Vallecitos

## **NRC NTR License Renewal Audit Questions Set 2**

QUESTION 001

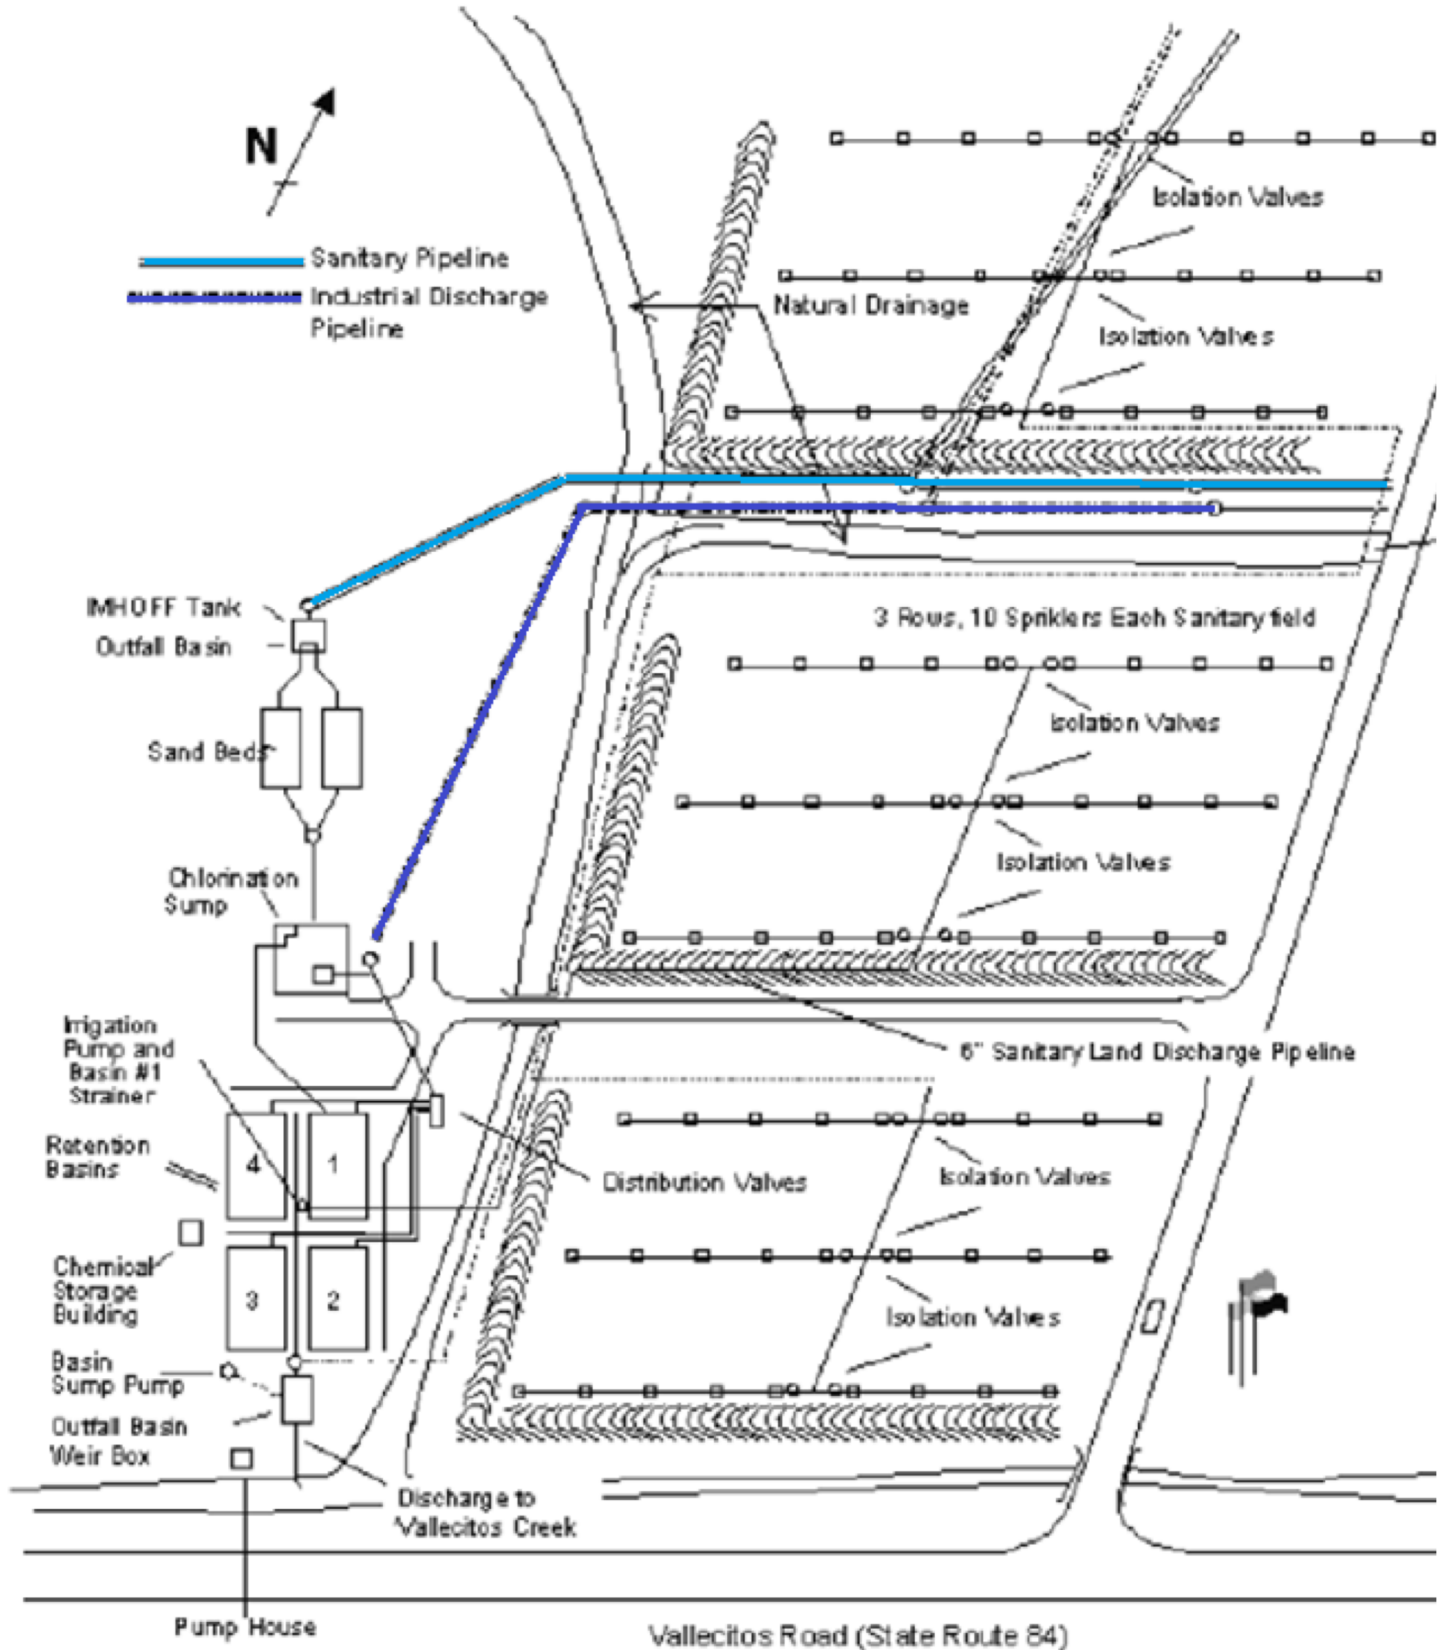
Provide a description (and illustration) of the configuration of the site retention basin(s), as referenced in Section 4 of the submitted Environmental Report.

The 2020 VNC Annual Effluent Monitoring Report contains the illustration provided on page 2 of this response and is available in USNRC Adams record keeping system under Accession # ML21060B458. The report has also been uploaded to the GEH / NRC shared reading room. Additional information on the retention basins can be found in the VNC Environmental Monitoring Manual, the most recent version of which has also been provided in the reading room.

Sanitary wastewater is treated in an Imhoff tank, filtered through sand beds, disinfected, and held briefly in one of the retention basins where it is tested for compliance with discharge limits before it is discharged onto GE-VNC's property by sprinkler irrigation.

Industrial wastewater, primarily once-through non-contact cooling water from NTR, the waste evaporator (WEP), machine shops, laboratory equipment, and storm water is drained directly to one of the 60,000-gallon retention basins, where it is pH adjusted, and tested for compliance with discharge limits before it is discharged onto GE-VNC's property by sprinkler irrigation.
